UNITED STATES PATENT AND TRADEMARK OFFICE

Office Action Summary	Application No. 10/814,806	Applicant(s) SALABERRIA, JAVIER BARANDIARAN	
	Examiner Andrew J. Rost	Art Unit 3751

DETAILED ACTION

Appendix for Mitchell (4,133,345) unlabeled parts

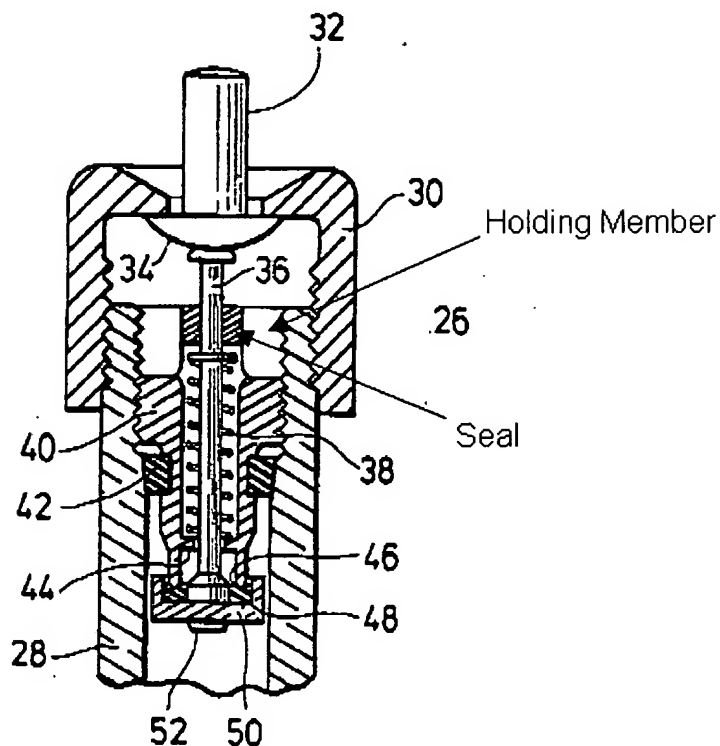
Regarding claim 1, Mitchell discloses a valve that has two concentric bodies (28, 30) with an intermediate chamber and a control rod (32) with a drive action area (top of actuating spindle 32) that resembles a semi-spherical surface with the force of actuation not limited to directions laterally and axially to the control rod.

In regards to claim 2, Mitchell discloses a valve device having three pieces (internal body portion 40, ring seal 42, and holding member (unlabeled, shown in attached Figure) that interact with sealing gaskets (closure member 48, and seal around the stem 36 (seal is unlabeled but shown in attached Figure)).
